ADDITIONAL INFORMATION REQUESTED FOR DA2021/0325

**Alterations & Additions
2 Dixon Avenue
Frenchs Forest 2086
Lot 1 DP31074**

Prepared by Lee Pracy
Qualified Draftsperson
PO Box 354
Oatley NSW 2223

Issued to Northern Beaches Council for Development Consent

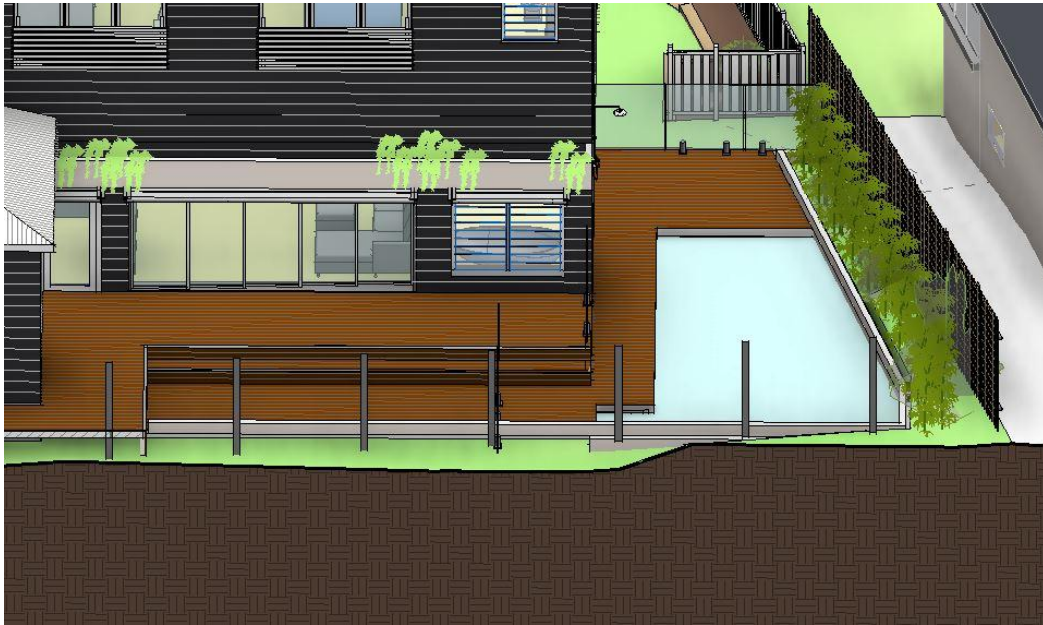
An Arboricultural Impact Assessment (AIA) is required to determine the impact of the proposed driveway upon the Paperbark within the road verge and the Gum on the front boundary. The AIA shall be accompanied by a tree sensitive root investigation undertaken by an Level 5 AQF Arborist along the alignment of the proposed retaining walling of the driveway.

On review the Paperbark street tree appears in good condition with a long safe useful life expectancy and Council will not support impact to this street tree. To this extent it is suggested the alignment of the driveway shall be altered westward to preserve the Paperbark.

Concern is raised regarding the proposed driveway, retaining walls, and the required excavation needed to facilitate the proposed garage which is below existing level. This proposed work is well within the Tree Protection Zone (TPZ), as well as Structural Root Zone (SRZ) of the existing Paperbark street tree located within the road reserve, as well as the existing Gum adjacent to the northern boundary. Upon review of these trees, both appear to be in good condition with a long safe useful life expectancy. In order to understand the full impacts of the proposed works, an Arboricultural Impact Assessment is required in accordance with Councils Development Application Lodgement Requirements. In addition to this, due to the proximity of proposed works and the expected encroachment within both the TPZ and SRZ, a tree root investigation is required to be conducted in accordance with AS4970-2009, specifically Clause 3.3.3 Major Encroachment. This tree root investigation should take place in line with the proposed driveway works, and if extensive significant roots are located, it is recommended that an alternative design be sought, as the removal of these trees would not be supported. The retention of these trees is vital to satisfying control E1, as key objectives of this control include "to protect and enhance the urban forest of the Northern Beaches", "to effectively manage the risks that come with an establishment urban forest through professional management of trees", as well as "to protect and enhance the scenic value and character that trees and/or bushland vegetation provide".

The findings of the report were that the proposed development will have insignificant impact on the existing Paperbark tree, and minimal impact on the Lemon Scented Gum. The sensitive root investigation in accordance with AS4970-2009, specifically Clause 3.3.3 Major Encroachment, found one root from the Lemon Scented Gum, approximately 60mm in diameter, along the alignment of the proposed driveway. This root was just outside the structural root zone (SRZ) of the tree, and thus the report determined that the development would not cause significant impact to the health and longevity of the tree.

The report found that the development recognises the horticultural and arboricultural significance of both trees, and appropriate construction setbacks have been made to allow for their preservation. No realignment of the driveway is suggested. The report recommends a number of tree preservation measures, including the appointment of an arborist to supervise the construction. The development will follow the recommendations of the report.
